Site Audit Report
0503-1301-A1
0503-1301-A2

Eastern Creek Business Hub
Rooty Hill Road South, Rooty Hill, NSW

51259/109504 (Rev 0)

NSW Site Auditor Scheme
SITE AUDIT STATEMENT

Figure 4 – Excavated Areas and Remediation Zones
Eastern Creek Business Hub,
Beggs Road, Rooty Hill, NSW

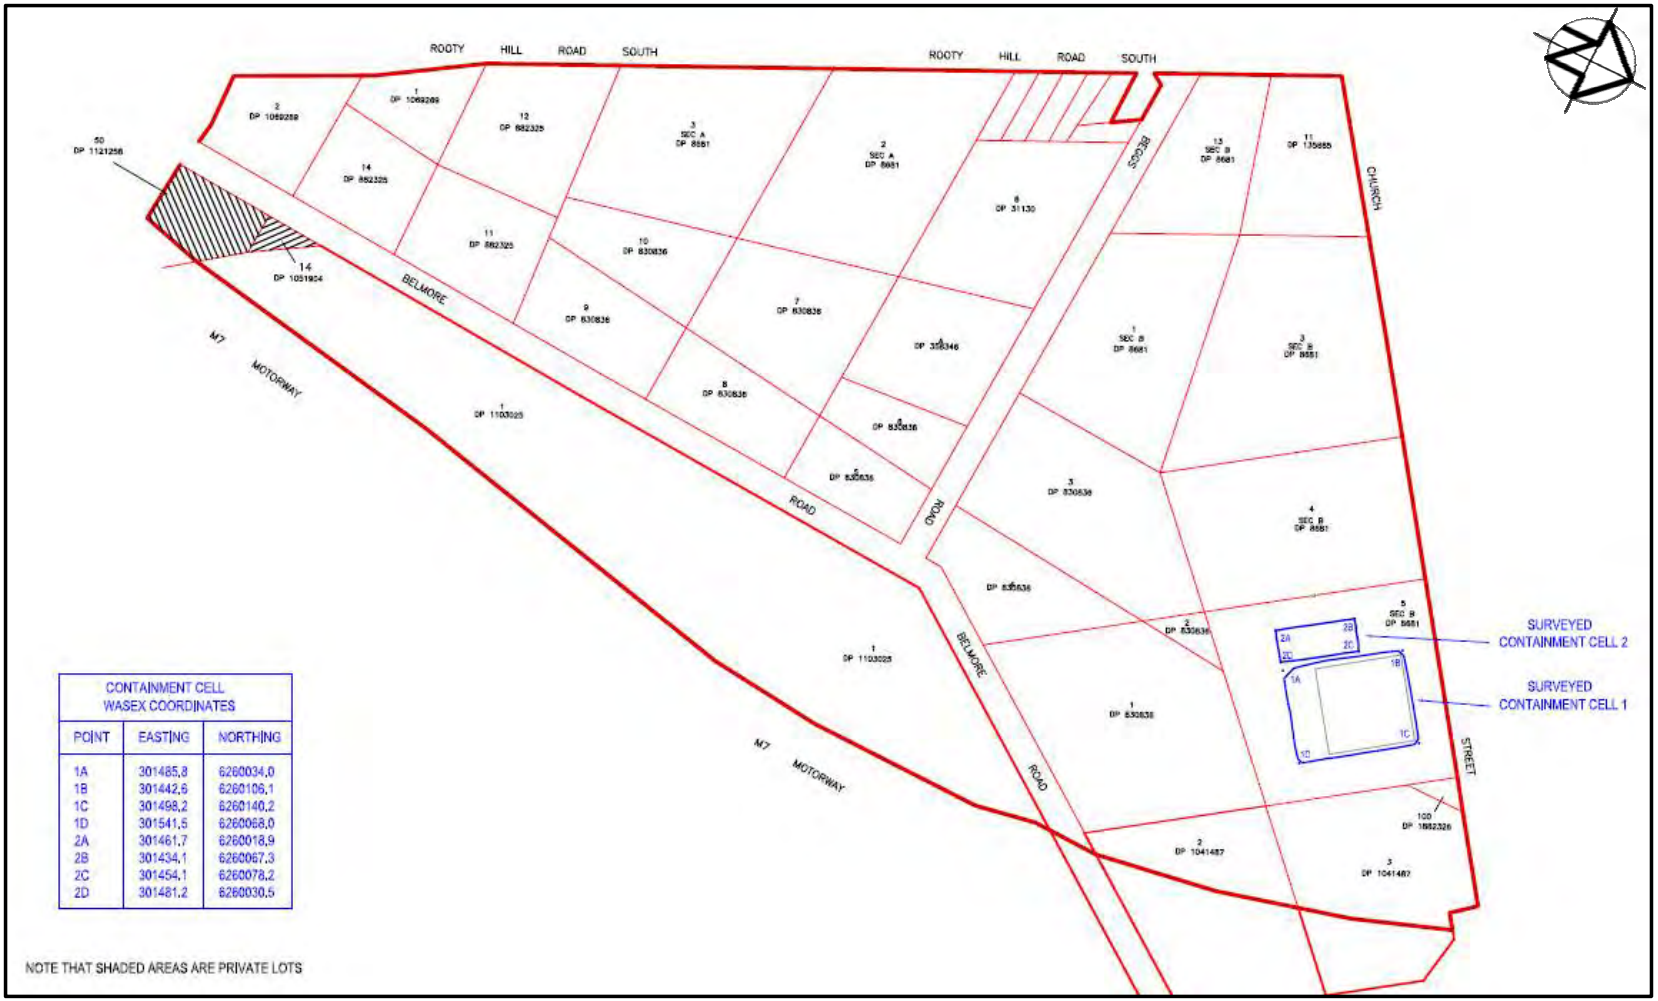
- Figure 4 shows a aqua / blue hatched area – the legend does not indicate what this relates to? Based on the legend it appears that this relates to 'suspected asbestos impact' which was not known in the draft version of the report.

Regarding the aqua /hatched in figure 4, I assume you are referring to the lots at the southern corner of the site? The hatch is simply denoting that they are private - which is just a pass over from our subdivision plan which was used by the Contractors surveyor. Irrelevant and therefore can be removed if you like to avoid any confusion? Let me know asap please.

DRAWING: FINAL ACM AREAS	JOB No.: 170069 / LGA: NA
	PLAN No.: 1012 / DATUM: AHD
CLIENT: ENVIROPACIFIC	DATE: 26/06/2017 / SCALE: 1:1000
PROJECT: ROOTY HILL	DRAWN: JP / CONT. INTERVAL: NA
ADDRESS: CHURCH ST, ROOTY HILL	CHK: / SHEET :1 OF 6

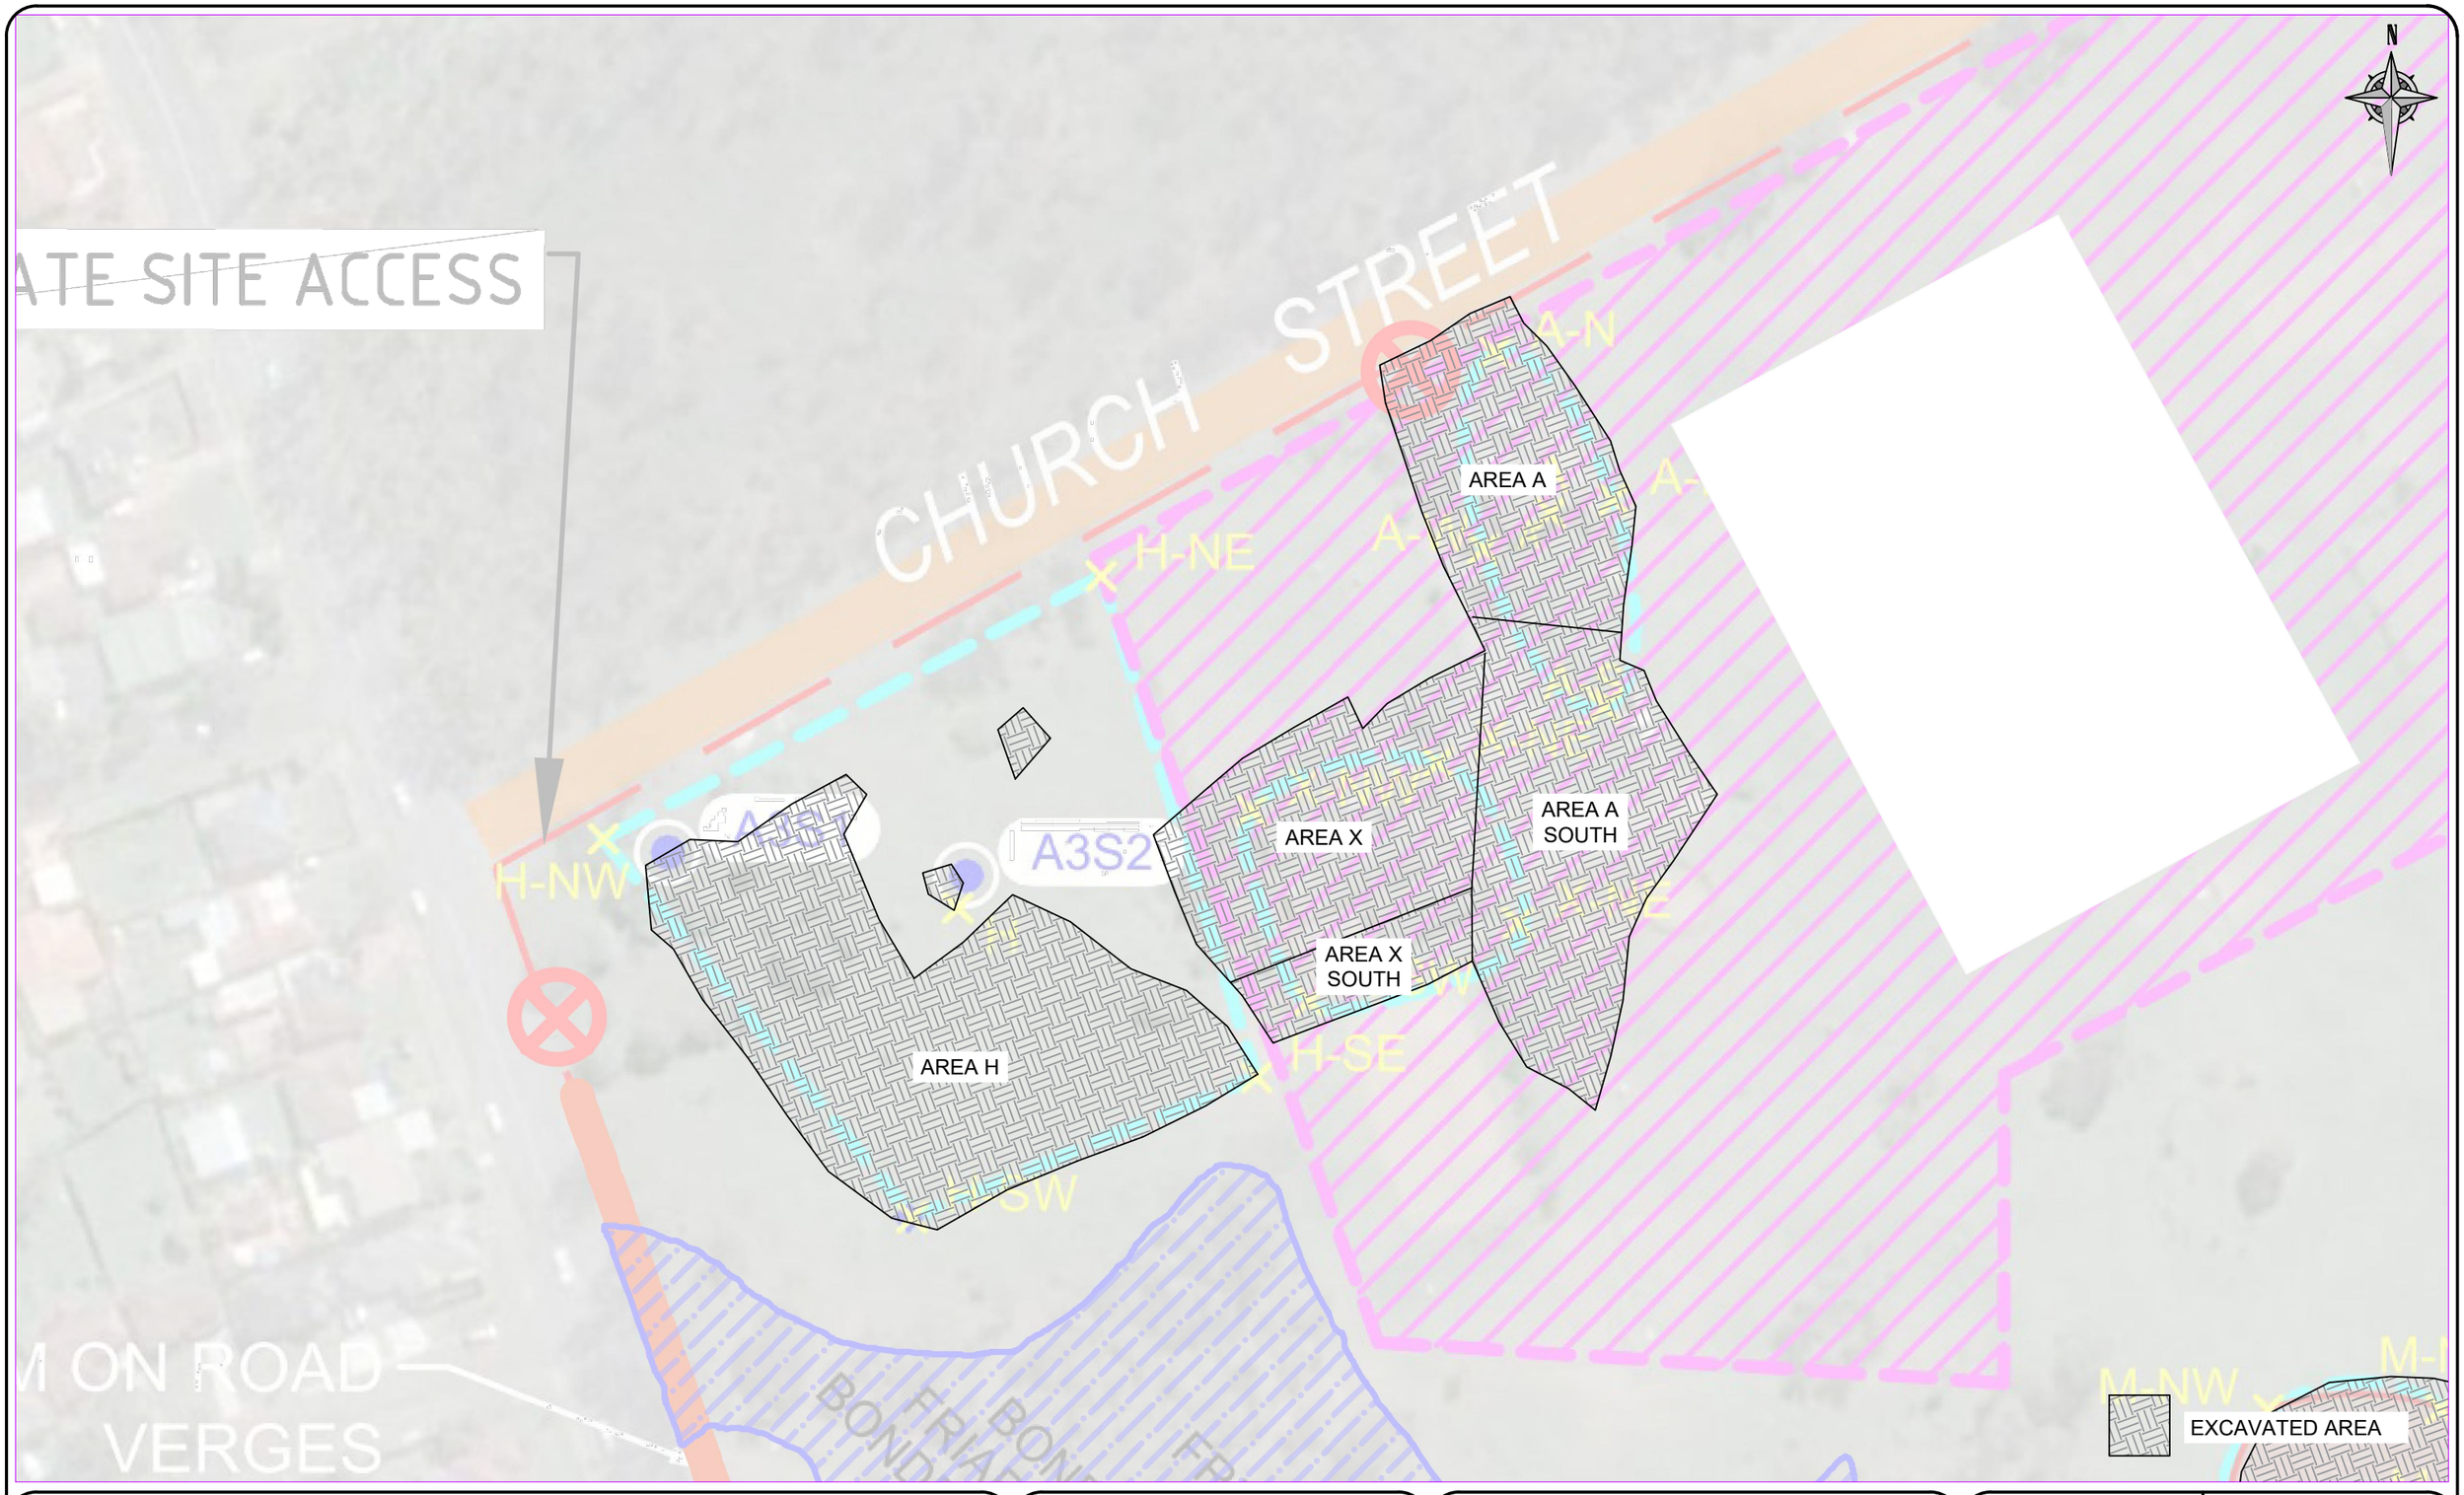
- Show the location of where the VENM material was excavated?
    - Show location of Area S Stockpile (asbestos rubble).
- Appendix B – Drawing 1 of 6

Figure 2 – Site Layout
Child Care Centre
Eastern Creek Business Hub,
Beggs Road, Rooty Hill, NSW

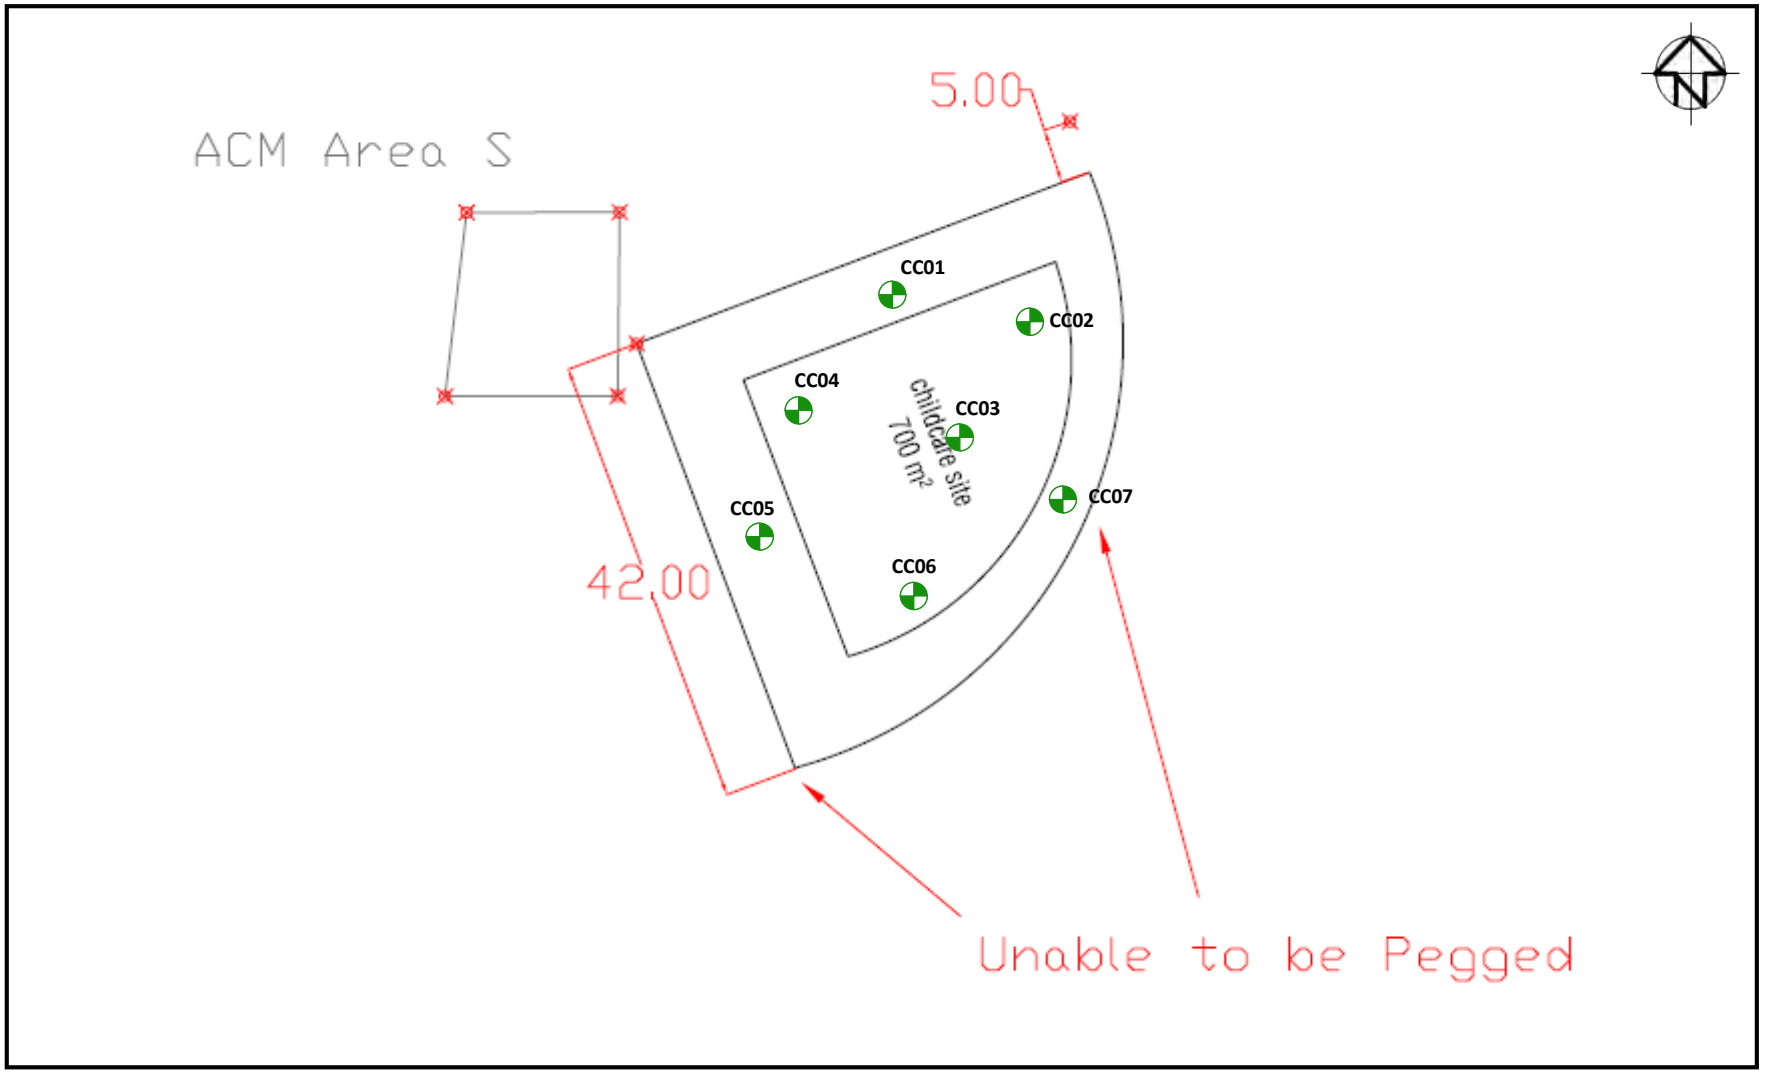
- Figure 2 –
    - Add the other markers as shown on the map in the legend.
    - Show Area S on the map.
    - Present the site playout of the child care centre as per the site plan provided in Figure 2 of WSP 2017a

Figure 3 – Sampling Location Plan
Child Care Centre
Eastern Creek Business Hub,
Beggs Road, Rooty Hill, NSW

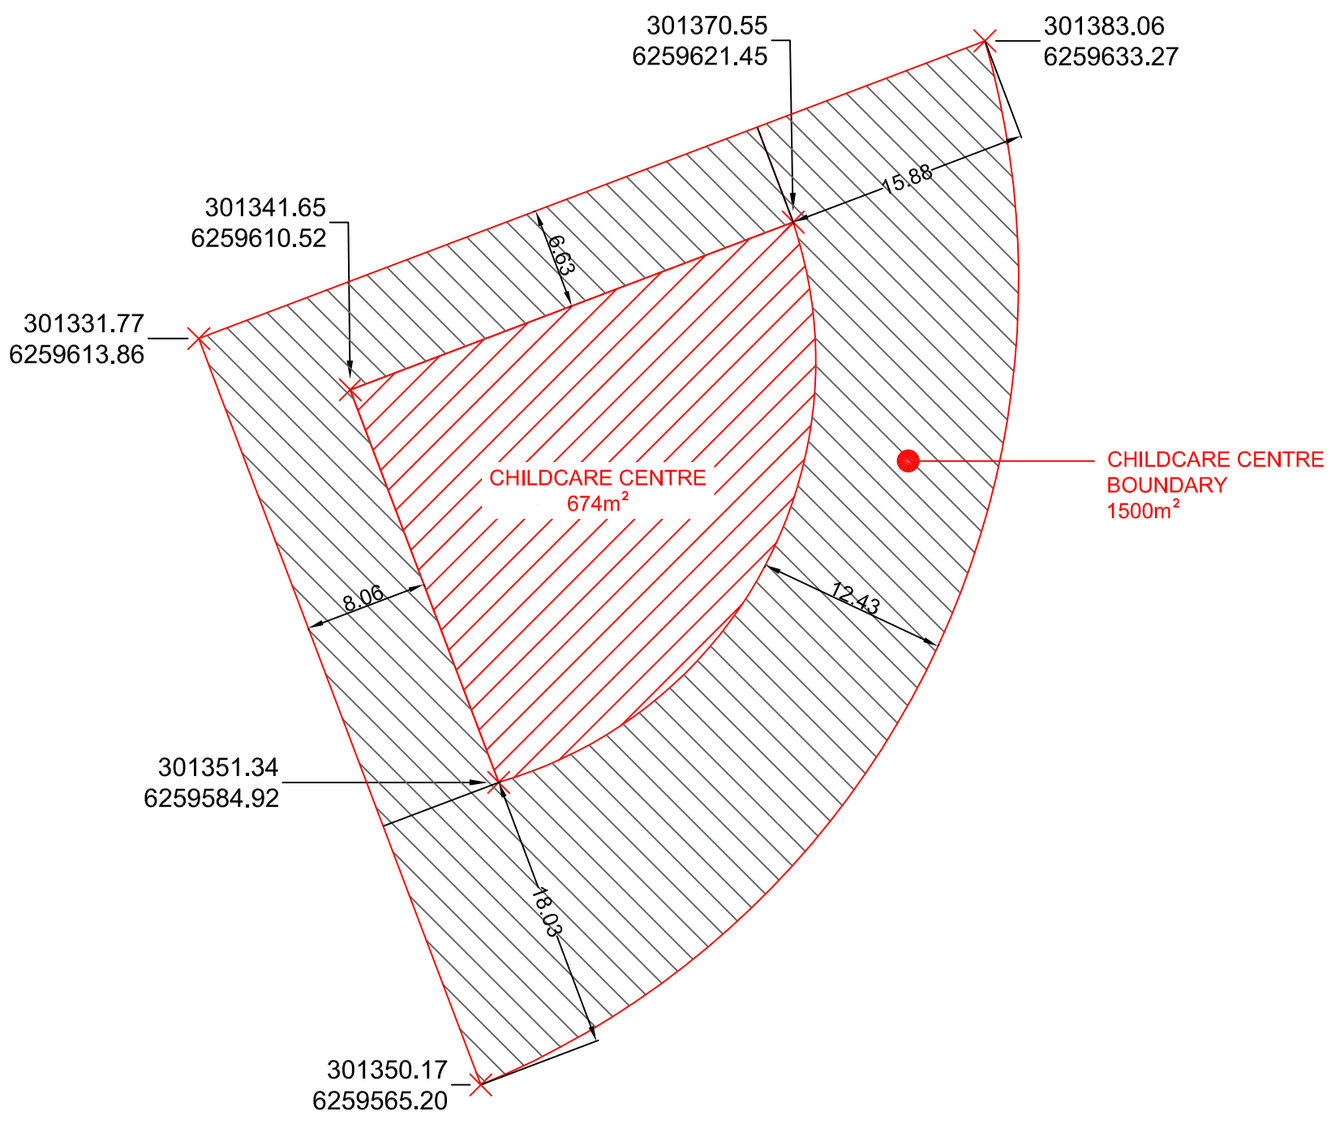
- Figure 3 – Surveyed coordinates of each boundary of the proposed childcare centre is required to be provided to the auditor.
